Mobile Intel® Celeron® Processor on .13 Micron Process in Micro-FCPGA Package

Specification Update

November 2003

Document Number: 251309-017

Figure 12. System Bus Reset and Configuration Timings

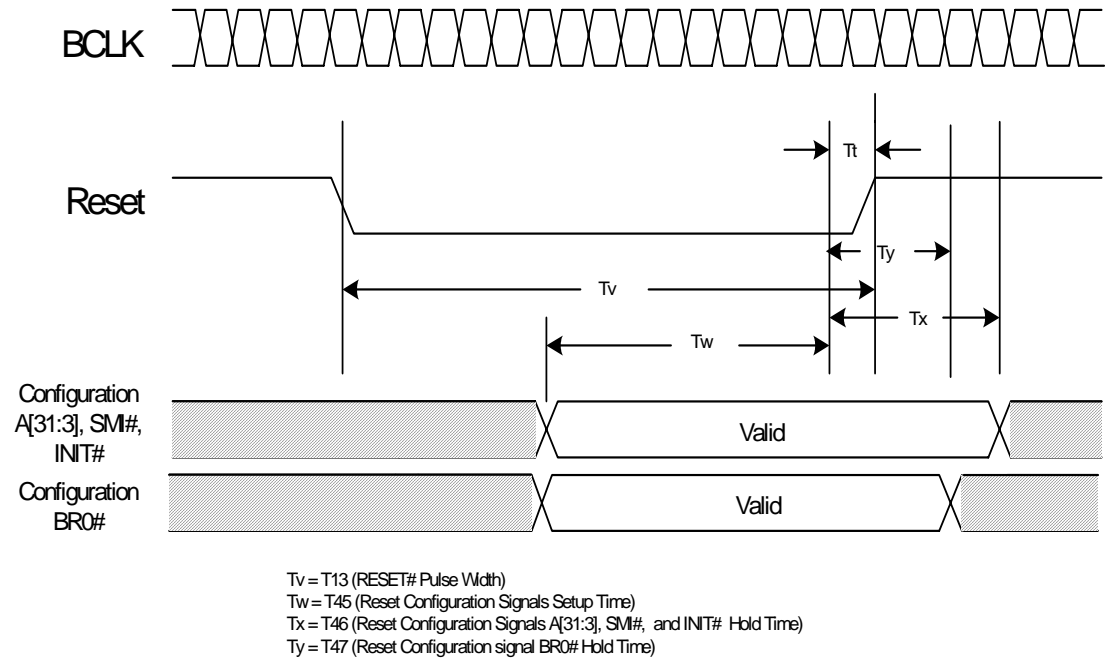
V2. BR0# Maximum Hold Time Specification Change

The BR0# maximum hold time has changed to 2 BCLKs. This change will be shown in the “System Bus AC Specifications (Reset Conditions)” table and “System Bus Reset and Configuration Timings” figure of the *Mobile Intel® Celeron® Processor on .13 Micron Process in Micro-FCPGA Package Datasheet*. This change will be incorporated in the next revision of the datasheet.

The following figure will be modified to reflect this change:

T# Parameter	Min	Max	Unit	Figure	Notes
T45: Reset Configuration Signals (A[31:3]#, BR0# INIT#, SMI#) Setup Time	4		BCLKs	13	1
T46: Reset Configuration Signals (A[31:3]#, INIT#, SMI#) Hold Time	2	20	BCLKs	13	2
T47: Reset Configuration Signal BR0# Hold Time	2	2	BCLKs	13	2

1. Before the deassertion of RESET#.
2. After clock that deasserts RESET#.
